**ADDENDUM
NO. 2**

**CROWN POINT COMMUNITY SCHOOL CORPORATION -
ATHLETIC TURF IMPROVEMENTS
Crown Point, IN 46307**

ADDENDUM TWO

Addendum Two (AD.02) to the drawings and specifications prepared by Gibraltar Design and The Skillman Corporation for **Crown Point Community School Corporation – Athletic Turf Improvements** for Crown Point Community School Corporation, Crown Point, Indiana.

NAILER CURB SECTION AT OUTFIELD MASONRY WALL
SCALE: 1 1/2" = 1'-0"

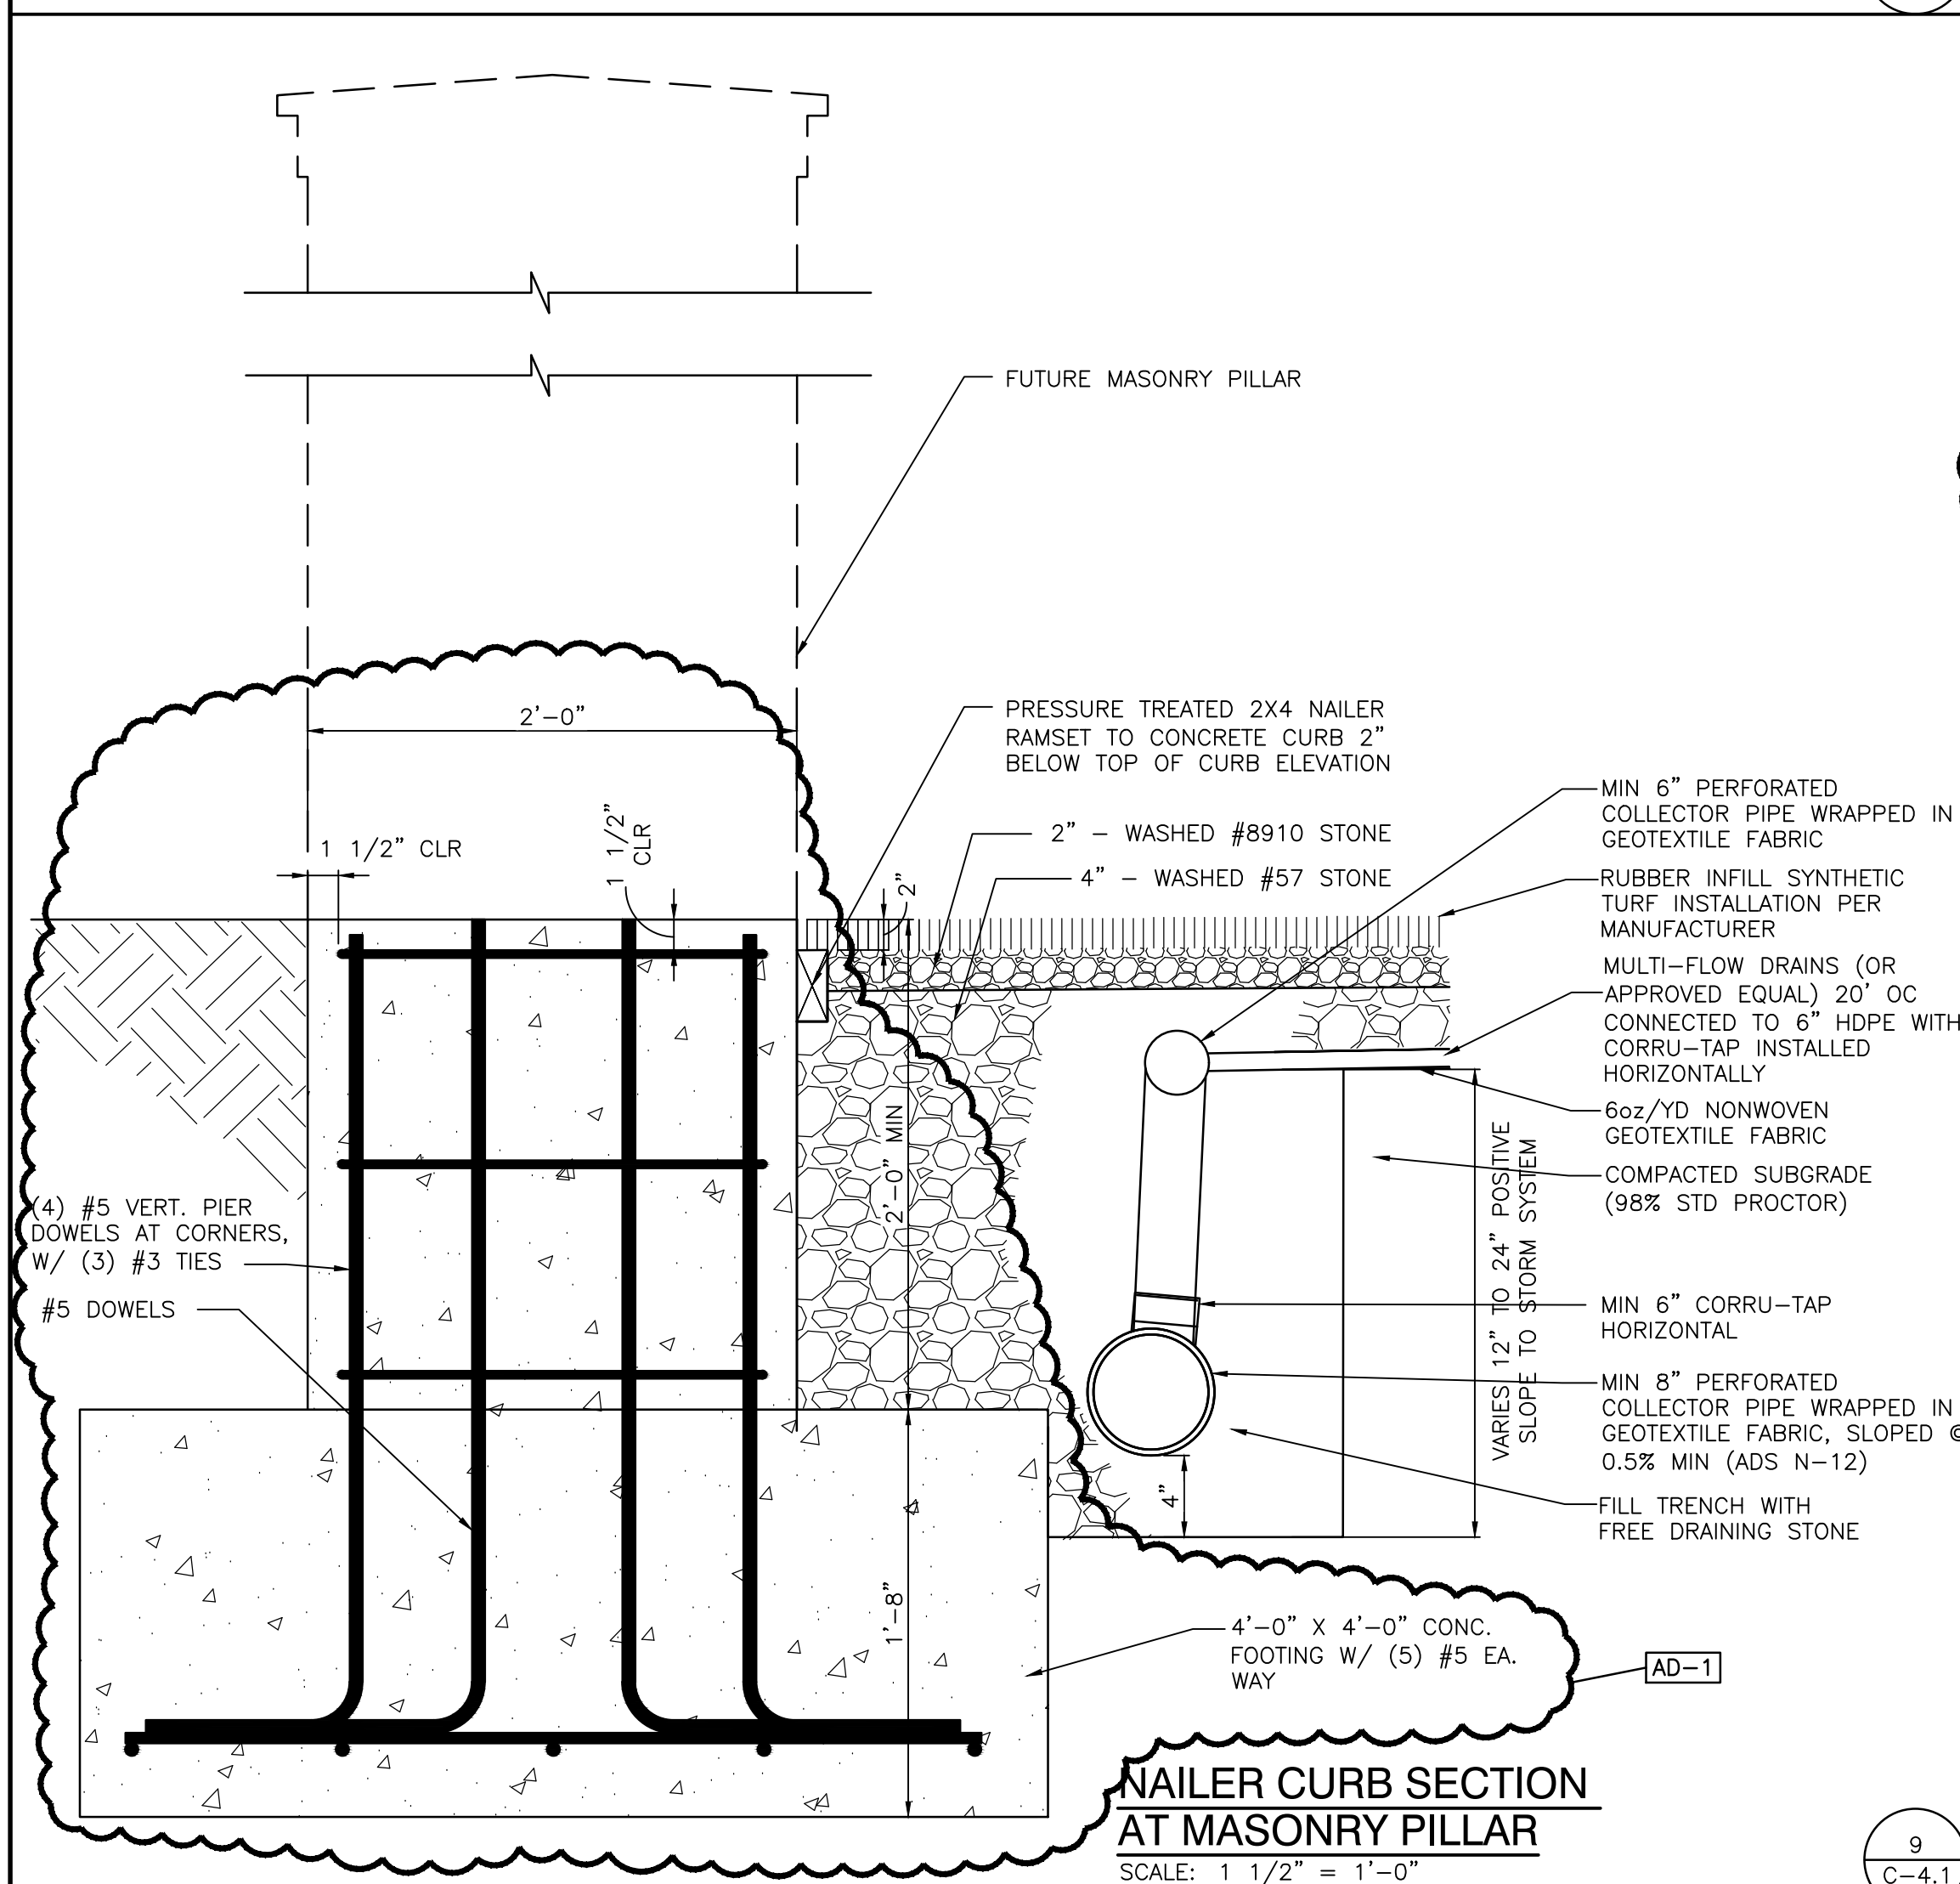
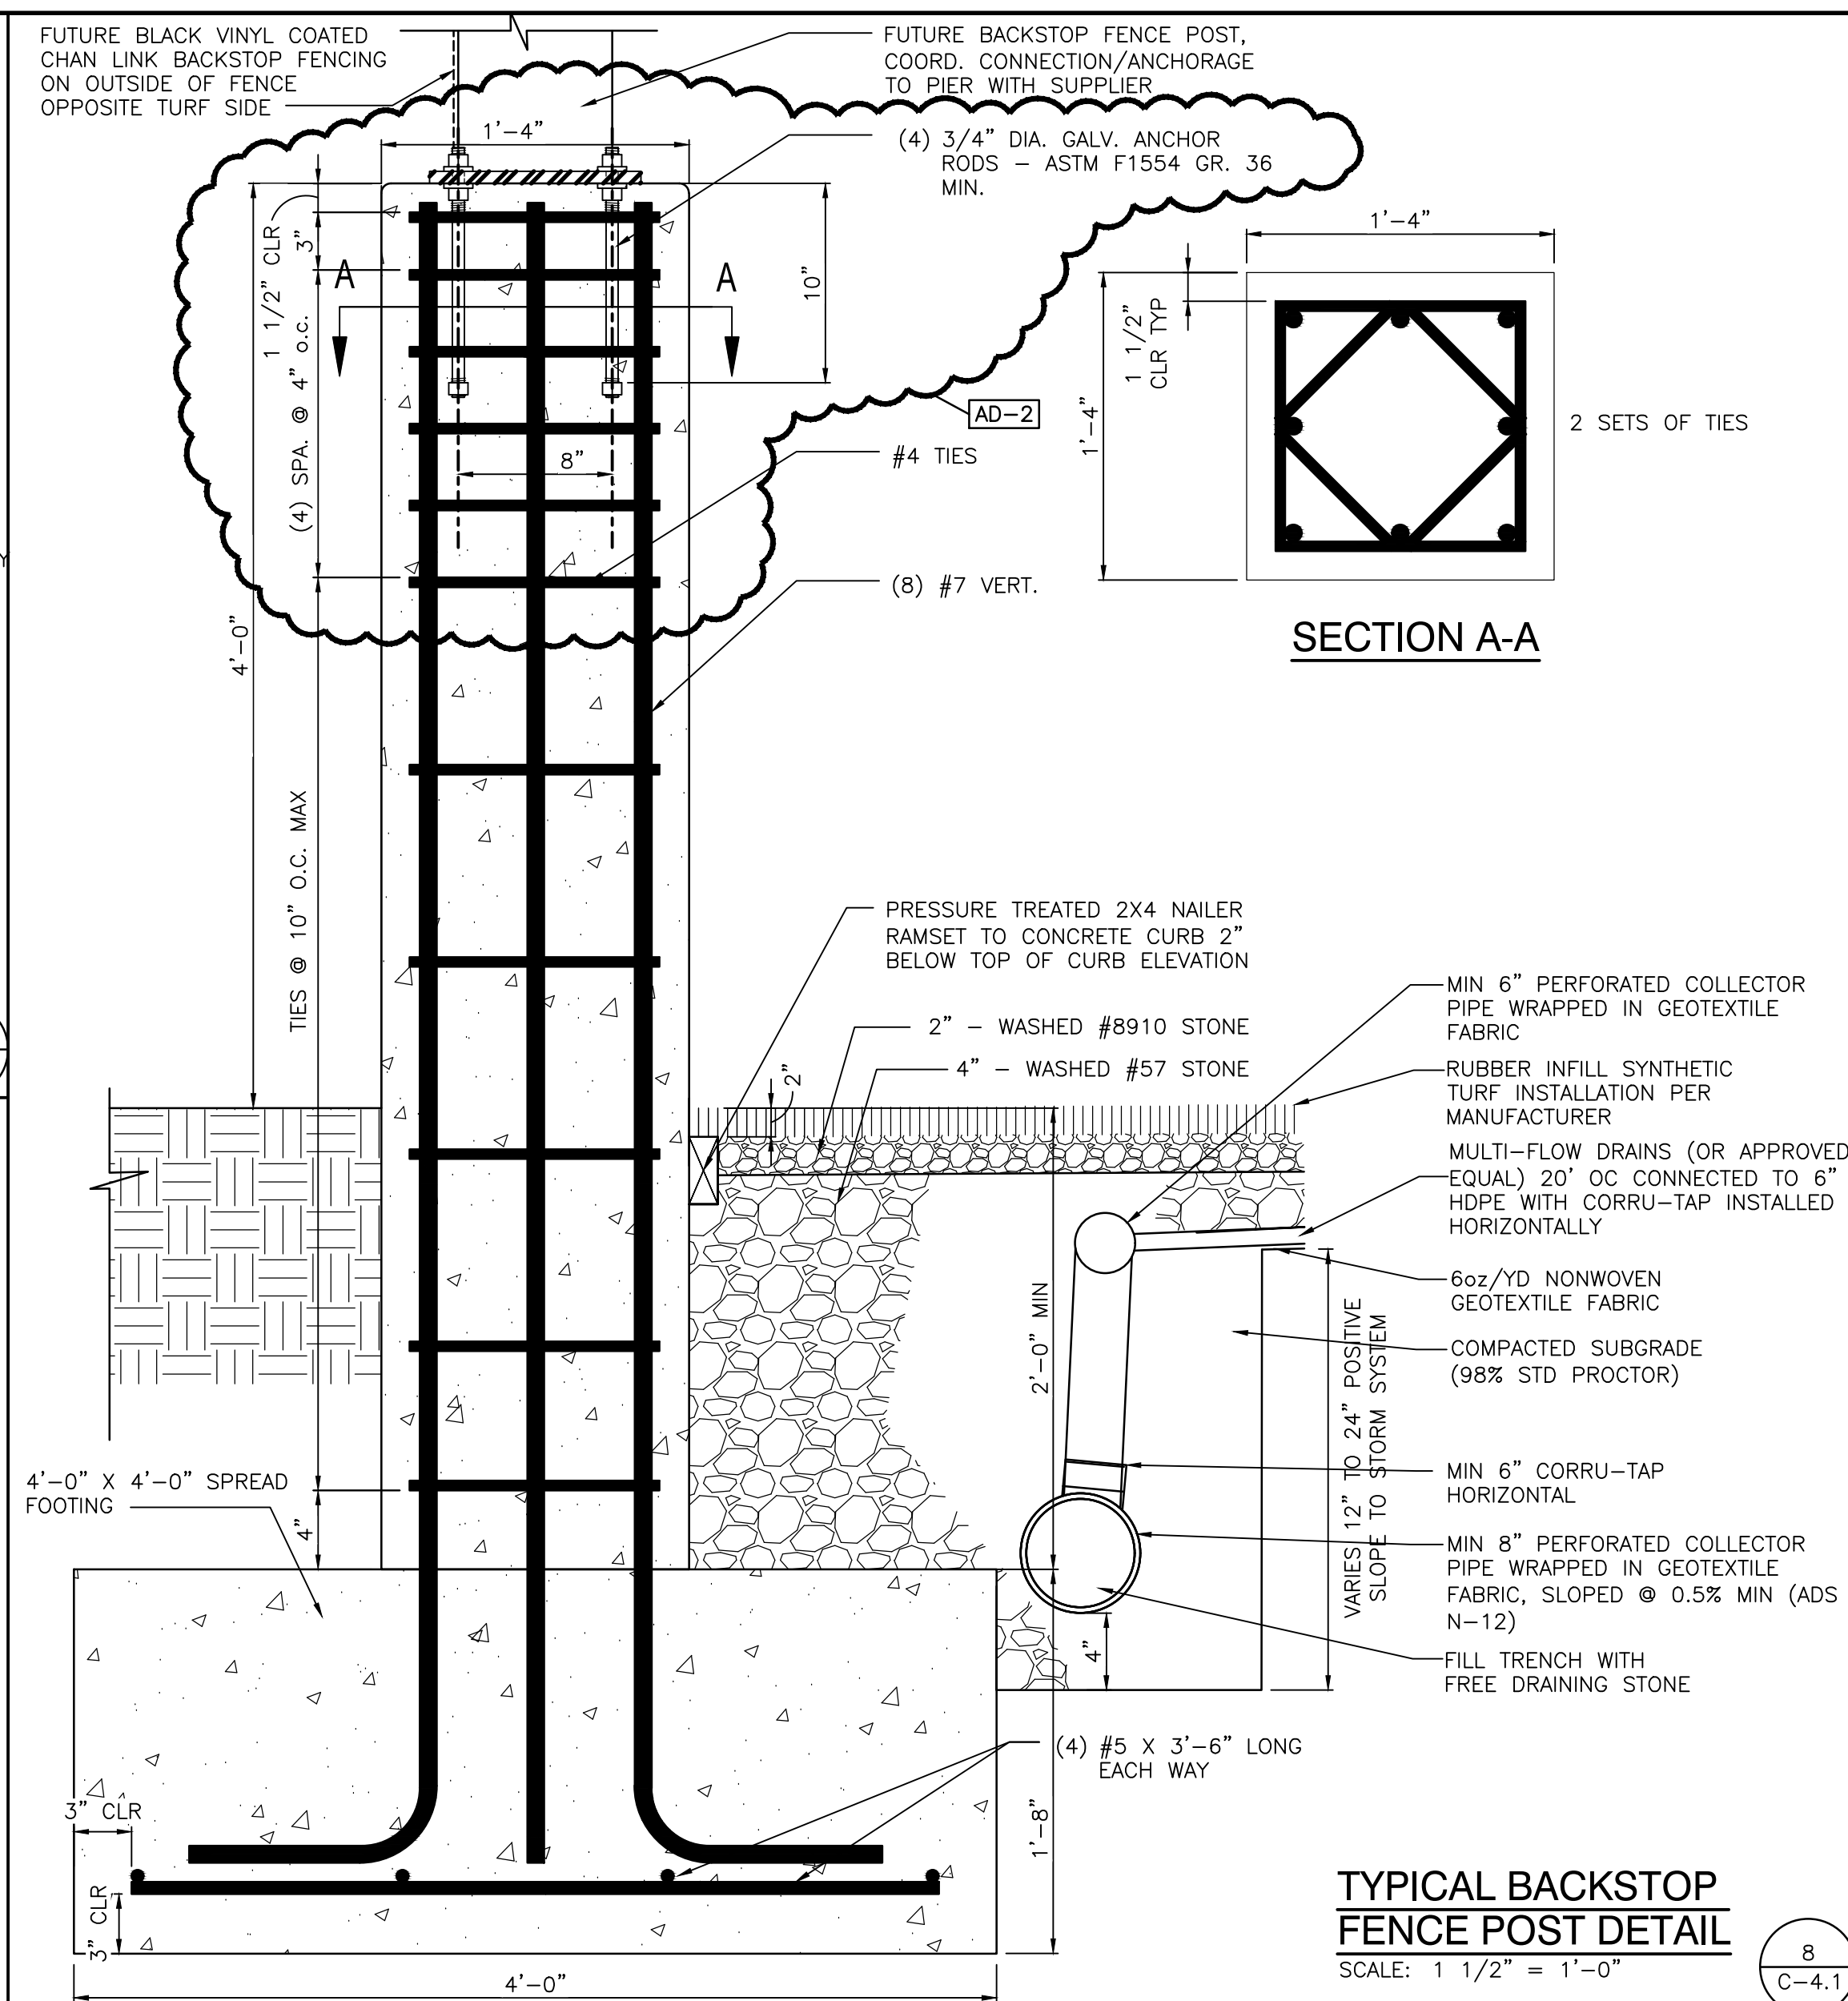
7. Sheet C-4.1

- A. Refer to revised, full-size drawing, included in this Addendum, for revisions to detail 5/C-4.1 and 8/C-4.1.
